Access Compliance Report

Public Rights-of-Way

(Curb Ramps)

Intersection ID: N/A	Main Street: CLARKSON_ST	Cross Street: DUNBAR_ST	Location: W
ADA ID: 22048CCDA803	Ramp Type: Perp	Initial Pass/Fail: Fail	Overall Compliance: No
		Severity Score: 8.75

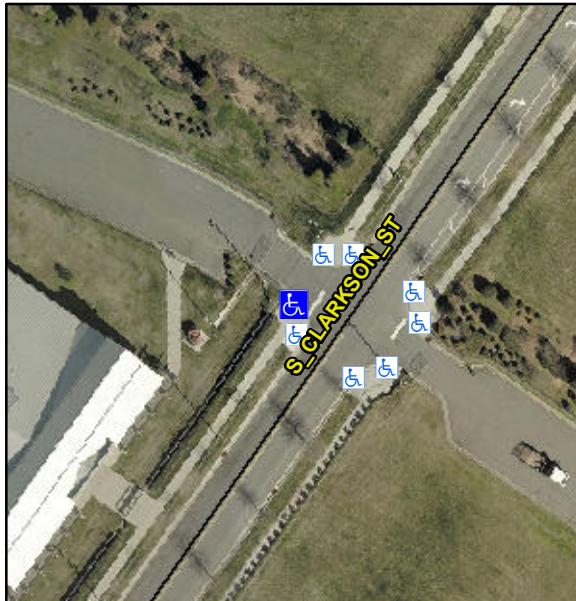
Not Found, R304.5.1

Compliance	Description	Data	Compliance	Description	Data
N/A	Ramp Length (in)	96.0	Yes	Ramp Slope (%)	8.0
No	Ramp Width (in)	47.0	Yes	Ramp XSlope (%)	0.9
N/A	Flare Type LT	N/A	N/A	Flare Type RT	N/A
N/A	Flare Slope LT (%)	N/A	N/A	Flare Slope RT (%)	N/A
N/A	Flare Traversable LT?	N/A	N/A	Flare Traversable RT?	N/A
N/A	Landing Length (in)	N/A	N/A	DWS Provided?	N/A
N/A	Landing Width (in)	N/A	N/A	DWS Contrast?	N/A
N/A	Landing Slope (%)	N/A	N/A	DWS Length (in)	N/A
N/A	Landing X Slope (%)	N/A	N/A	DWS Full Width?	N/A
N/A	Landing Curb? (Y/N)	N/A	N/A	DWS Offset (in)	N/A
N/A	Shared Landing?	N/A			
N/A	Gutter Ponding?	N/A	N/A	Gutter Slope (%)	N/A
N/A	Gutter Lip Ht (in)	N/A	N/A	Gutter X Slope (%)	N/A
N/A	Painted X Walk1?	No	N/A	Painted X Walk2?	N/A
	X Walk 1 Direction	To NE		X Walk 2 Direction	N/A
N/A	X Walk 1 Width (in)	N/A	N/A	X Walk 2 Width (in)	N/A
	X Walk 1 Slope (%)	2.3		X Walk 2 Slope (%)	N/A
	X Walk 1 X Slope (%)	2.8		X Walk 2 X Slope (%)	N/A

N/A	Ramp inside XWalk1?	N/A	N/A	Ramp inside XWalk2?	N/A
	Road Slope (%)	N/A	N/A	Clear Space?	N/A
	Road X Slope (%)	N/A	N/A	Clear Space to XWalk (in)	N/A
N/A	Any Obstructions?	N/A	N/A	Storm Grate/Utility Hazard?	N/A
	Obstruction Type			Storm Grate/Utility Type	
		N/A			N/A
			Yes	Surface Condition? (G/P)	Good

Possible Solutions:

Remove & Replace Entire Ramp.
